**Cambridge MTS #1 – Install four new 27.6 kV Feeder Positions
Notification of Approval of Connection Proposal
CAA ID Number: 2006-EX287**

ASSESSMENT SUMMARY

Cambridge and North Dumfries Hydro Inc.

Figure 1: Historical Power Factor

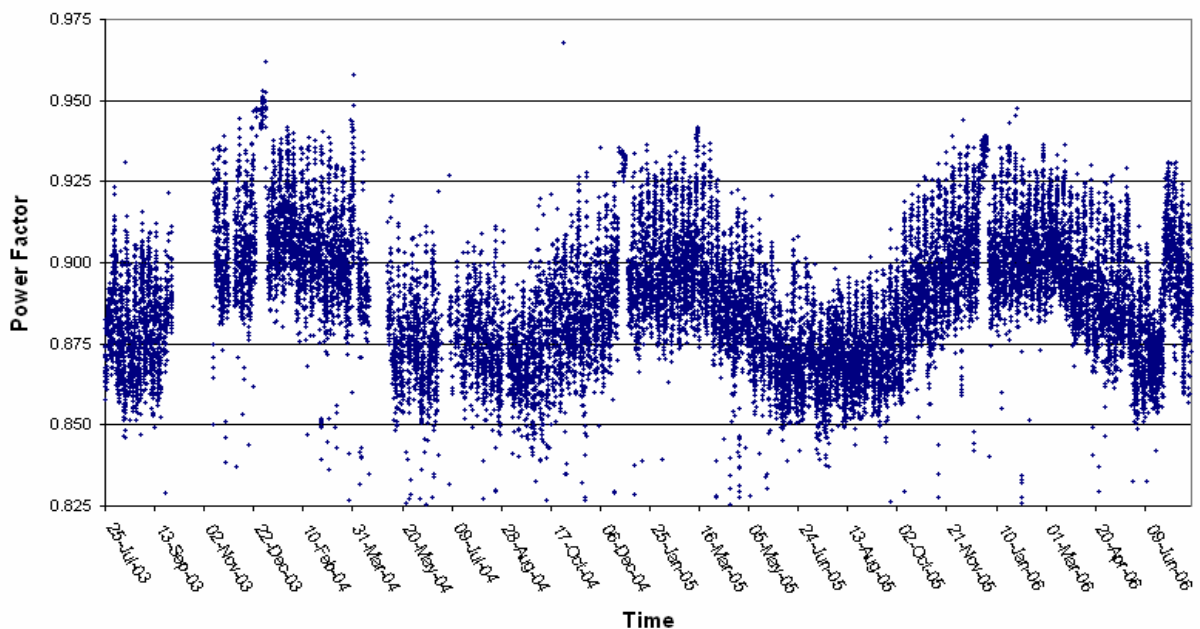
At present, Cambridge and North Dumfries Hydro Inc. do not meet the power factor requirements of the System Impact Assessment issued in 2002 for the station. The preliminary assessment report for Cambridge MTS #1, recommended that low voltage shunt capacitors be connected to the MTS #1 feeders to alleviate expected power factor deficiencies.

Operational information for a 3 year period show that the power factor at Cambridge MTS #1T1 and T2 has been below 0.9 for long periods of time. This is illustrated in figure 1 below.

Based on IESO records, the lowest pf point at Cambridge MTS #1 between July 2003 and July 2006 occurred on June 20, 2006 at 22:00 with a value of 0.724. The actual values were as follows:

According to Cambridge and North Dumfries Hydro Inc., there are two 1200 kVAr capacitor banks currently installed on low voltage feeders at Cambridge MTS #1 with plans to install an additional six 1200 kVAr capacitor banks during 2007. They have stated that they will achieve a power factor of 90% at Cambridge MTS#1 by the summer of 2007. This value will decline as the load increases, therefore, additional capacitor banks will have to be installed.

The 2007 forecast of 79.2 MVA @ 86% pF results in 68.1 MW and 40.4 MX. Adding capacitor banks totaling 9600 kVAr increases the power factor to 91.1 %.

- to achieve 90% lagging pF at Cambridge MTS#1, Cambridge and North Dumfries Hydro Inc. must provide to the IESO a plan, before September 1, 2007, to install the required power factor correction devices with in-service dates. Power factor devices installed on the station's LV bus will have to undergo a connection assessment and be approved by the IESO. Devices installed at the customer stations will have to be reviewed by the distributor.
